TECHNICAL INFORMATION

TYPE NO <p style="text-align: center;">FB/IN/ES 5100</p>	TYPE <p style="text-align: center;">FB/IN/ES</p>	T.I.-NO <p style="text-align: center;">... 06/01</p>				
SERIAL NUMBERS AFFECTED From machine number 500513		ISSUED BY Documentation/ Wittenborg Odense				
SUBJECT <p style="text-align: center;">Vending machine controller 47107602</p>		ISSUED FOR (X): <table border="1" style="width: 100%; border-collapse: collapse;"> <tr> <td style="padding: 2px;">Action</td> <td style="width: 20px;"></td> </tr> <tr> <td style="padding: 2px;">Information</td> <td style="text-align: center;"><input checked="" type="checkbox"/></td> </tr> </table>	Action		Information	<input checked="" type="checkbox"/>
Action						
Information	<input checked="" type="checkbox"/>

New part No: 47107602 ver. 1.1 Vending machine controller

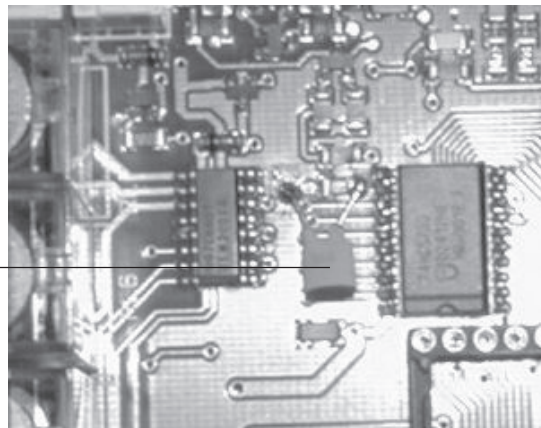
- From the above machine number a noise capacitor 100pF will be mounted on the above mentioned vending machine controller.

Noise capacitor

- In some machines it could happen that the SPC did not respond on a selection. Noise from the fan motor relay could disturb the electronics.
After having mounted the noise capacitor 100pF the problem has been solved.
